Thomas Wolfe Auditorium
U.S. CELLULAR CENTER
Ashville, North Carolina

Report of Impact to Structural due to Recommended Renovations

Prepared for
Threshold Acoustics

July 10, 2015

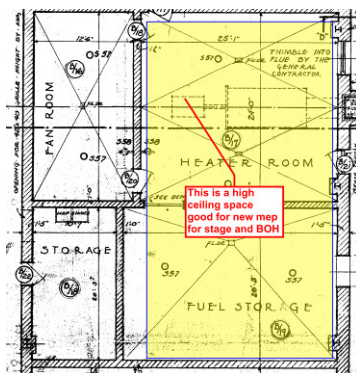
- Remove the two mechanical units suspended above the ceiling of the auditorium (which will be demolished) and all accompanying ductwork, including the supply air doghouse. This is a high value item for many reasons including providing a significant mass credit for use in other renovations noted above in and around the roof, ceiling, and catwalks. This has a net positive impact to structure. *For estimating there is no added structural cost associated with this modifications*

- Remove the mechanical unit serving the stage located in the enclosure constructed on stage left. Demolish this enclosure in its entirety. This item is a high value modification that will basically help to return the structure to that of the original design reducing mass that was added in a previous renovation. *For estimating there is no added structural cost associated with this modifications. There will be cost to add portions of the floor back in to create functional space but that will be included in other areas.*

- Install new mechanical units to serve the auditorium. Locate these units on the roof above the lobby addition constructed in the 1970's. Provide supply and return ductwork to the auditorium through the newly installed soffits (described above). This modification is necessary and has no impact to the existing auditorium but will require a moderate cost to prepare the lobby addition to support the added load and mass. It is a high value item because the mass is not being added back to the existing auditorium but is being added to the lobby expansion structure that is a more up to date structure. *For estimating there will be added steel dunnage at the new roof of about 5 tons. Some retrofit of the existing structure is likely to be needed but a seismic upgrade of the existing structure is not anticipated. Include an additional 5 tons of complicated structural steel to be installed via scaffolding to support the new unit on the existing structure.*

- Install a new mechanical unit to serve the stage. Locate this unit in the basement beneath the dressing room level. Provide new supply and return ductwork. This modification is a high value and moderate cost item. The impact to structure will be the installation of support structure for the MEP unit and the creations of openings in the floors to allow for ducting. The weight for supplemental steel to support floor openings is offset by the weight of the concrete floor removed for a net zero add. It has a low to null impact to structure as only a small amount of duct is added and a small amount of floor is removed. The weight of the MEP unit will be located closer to the foundation having a low impact to the structure from a seismic standpoint. *For estimating there is no added structural cost associated with this modifications except for the support dunnage. Include 5 tons of structural steel for the dunnage. Also include the cost for creating openings in concrete floors and approximately 5 tons of additional miscellaneous steel to provide support at two primary floor openings.*

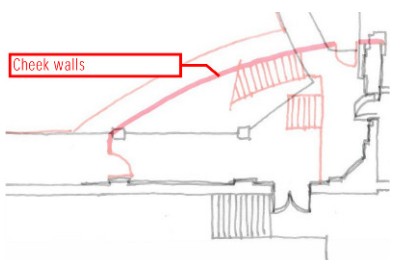
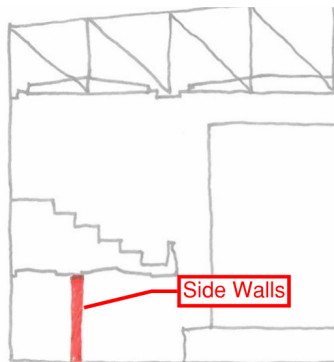
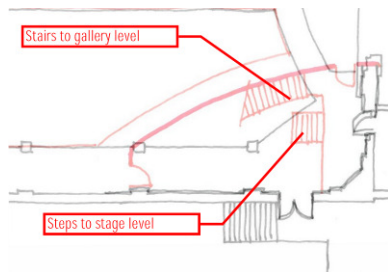
- Construct curved cheek walls on both sides of the auditorium immediately in front of the proscenium opening from orchestra seating level to the underside of the roof deck. Assume metal framing with three layers of drywall on the outer side (facing the auditorium). Construct around the existing side gallery structure. The installation of the cheek walls is obviously a high acoustical value and is a necessary modification. The construction must be as light weight as possible so that a relatively small amount of mass credit is used from that accumulated above. It must also be done in a symmetrical manner as noted. It is expected that a grid of HSS steel shapes will be required to create support for the metal studs and dry wall construction. Based on similar walls the vertical HSS sections are likely to be HSS 20x8 sections at 10 ft

on centers. It is a moderate use of any mass credits but must be carefully executed. *For estimating assume metal stud framing with drywall attached the existing structure. Allow for 16 tons of HSS 20x8 sections and 8 tons for curved horizontal support members. Allow an additional 6 tons total of small sized complicated steel at the ceiling for kickers to the existing structure and roof. And lastly add 8 tons of miscellaneous steel to be added below the floor to locally reinforce the support members.*

- Construct steps within the cheek wall enclosures on both sides of the house connecting orchestra seating level with stage level. Include a wheelchair lift within the cheek wall enclosure on house left to provide an accessible route. These steps use a relatively low amount of overall mass credits but is necessary for the functional use of the space. Light weight steel and concrete filled pan stairs is likely the best choice from a cost and mass standpoint. This modification requires the use of some mass credits and must be done in a symmetrical manner. The wheel chair lift will have a small impact to structure but mainly in a local manner. The use of a lift that does not require a pit to be cut into the floor structure is strongly encouraged so that the floor diaphragm in this area can be preserved for other potential floor cuts. *For estimating other than the cost of the stairs, there is no added structural cost associated with this modifications.*

- Construct stairs within the cheek wall enclosures on both sides to connect stage level with the gallery level. The comments on this modification is similar to that above for the addition of stairs between the orchestra seat and stage noted above. *For estimating there is no added structural cost associated with this modifications except for the stairs.*

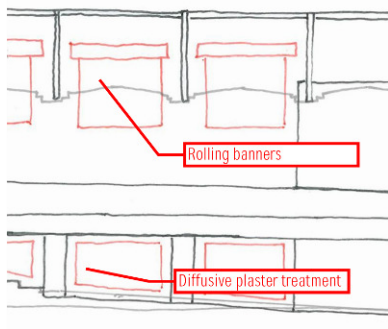
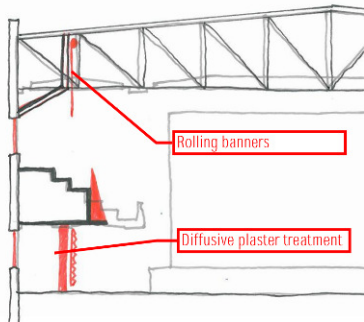
- Construct new walls at the orchestra seating level between the new cheek walls and the existing cross aisle location. This modification will use mass credits which will need to be identified.

It may be that the soffit of the side bay could be replaced with a lighter weight ceiling allowing a mass credit to be used for the wall in that local area. The ceiling modification may already be necessary for MEP upgrades. It is a high value modification with a relatively low cost and null impact to structure if mass credits can be obtained from the ceiling in the corridor or possibly from the next item below. *For estimating other than the primary CFMF construction there is no added structural cost associated with this modifications.*

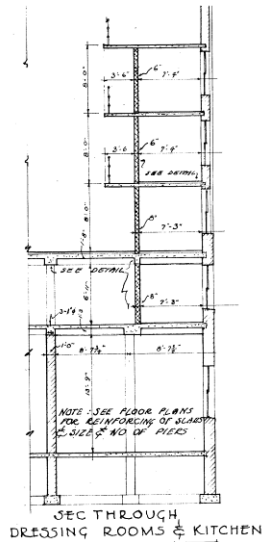
- *Demolish a portion of the orchestra seating level floor (both the original structural floor and the topping slab added later). Provide supporting structure around the penetration as required. This will include demolition of an existing structural steel beam encased in*

- *Construct a raised floor and walls enclosing a new wagon storage areas. See combined response below.*
- *Install a pit lift system consisting of:*
 - *One pit lifts, each of which can be positioned independently at the new wagon storage level, an orchestra pit level, audience seating level, and stage level.*

See combined response below.
 - *Chair wagons for the pit lift that can be rolled from the wagon storage areas onto the lift and raised to audience level to provide seating. See combined response below.*
- *Note that this option would be in lieu of the purchase of both stage extension system as described above. See combined response below.*

The above modifications would be of very high value at a high cost. To avoid a seismic upgrade the pit size and opening should be minimized. The impact to structure is not significant if the pit opening is small as compared to the whole floor diaphragm. If a small lift is used a dressing stair opening at the stage would be acceptable. The addition of supplemental wagon storage under the seating area is a good value at a low cost and little impact to the primary lateral structure. *For estimating assume that the option is to include a small pit and lift with a wagon storage in the assembly area. Assume that approximately 20 tons of structural steel will be needed to reinforce the opening.*

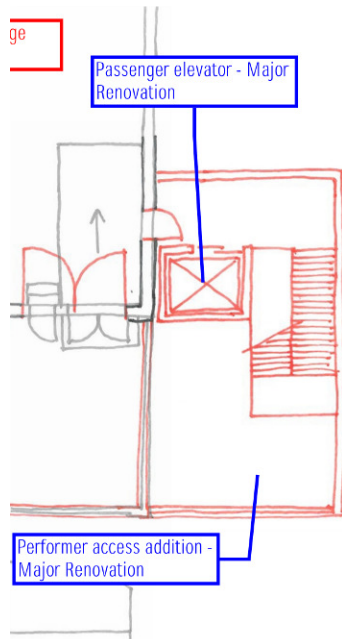
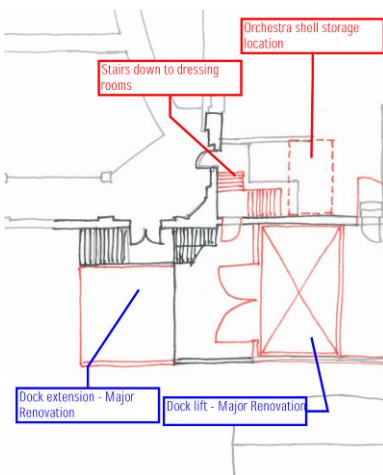
- *Construct an addition on the southeast corner of the stage to house. Assume the structure underneath the new platform lift and loading dock will be exposed steel pylons. Include the following access-related items:*
 - *At ground level, a performer's entrance and security check point (when required for shows) with access to a passenger elevator and stairs connecting to the loading*

- *At dressing room level, access to the passenger elevator and stairs. See combined comment below.*
- *At loading dock/stage levels, a large platform lift connecting the loading dock to the stage level, new large loading doors into the stage, and access to the passenger elevator and stairs. See combined comment below.*

- *Expand the loading dock platform outside the new addition to create additional staging area for loading and unloading of trucks. See combined comment below.*

- *The following is a combined comment on the above proposed modifications which would complete the basic needs for the functioning of the back of house and stage. For most of these modifications there would be little to null impact to the base structure as most of the work would involve standalone independent structures. The cost would be high as an elevator would be involved but the structure would (could) be very simple..*

Based on the site visit the best value would be obtained if these structures were all new. Adding onto the existing loading dock would likely involve workarounds and strengthening of what concrete, steel and masonry in-fill. The entire structure could be made of composite steel and braced frames for quick erection. Infill of the steep ramp to create a flat access is a high value as witnessed during the load-in and load-out of the two venues that were observed. **It is the writer's opinion that the loading dock and ramp to the stage should be updated irrespective of the direction of the future work.** *For estimating assume that this work would be equivalent to the addition of a multistory enclosed elevator and stair tower. Allow for approximately 20 psf of moderately detail complicated structural steel for the building. This would amount to almost 16 tons for the addition. Assume normal steel braced frames with steel beams, 3" 20 gage metal deck, composite studs and 4 1/2 inches of concrete topping. Assume spread footings for*

For estimating assume that the loading docks will use galvanized steel braced frames (approximately 30 tons) with concrete slabs. An alternative would be a CIP concrete footings, columns, and floors. Assume (10) 2'x2' reinforced concrete columns on spread footings with an 8" thick concrete slab and 24"x24" beams on all sides and 10 feet on centers max. Total reinforcing for a multilevel loading dock of approximately 20'x 80' is 20 tons of galvanized rebar.

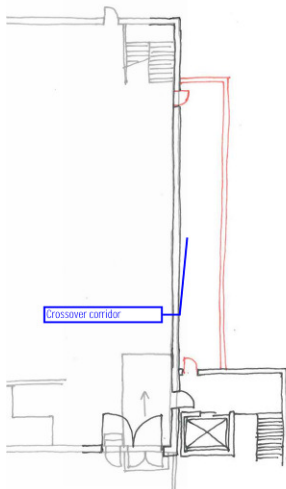
Install a new crossover corridor behind the stage. Construct with framed walls with exterior masonry cladding. This modification would be a high value and relatively low cost depending on the ability to install foundations below. If a standalone structure it would have null impact to the base structure. For estimating assume that this work would be equivalent to the addition of a single story covered enclosed. Allow for 10 tons of simply detailed structural steel for the building. Assume normal steel braced frames with steel beams, 3" 20 gage metal deck, composite studs and 4 1/2 inches of concrete topping. Assume spread footings for

- *Assume the corridor addition is constructed on exposed metal structure below (not enclosed). This modification would be a high value and relatively low cost. If a standalone structure it would have null impact to the base structure and if light weight would be less costly. For estimating this would be similar to that above with the enclosure removed.*
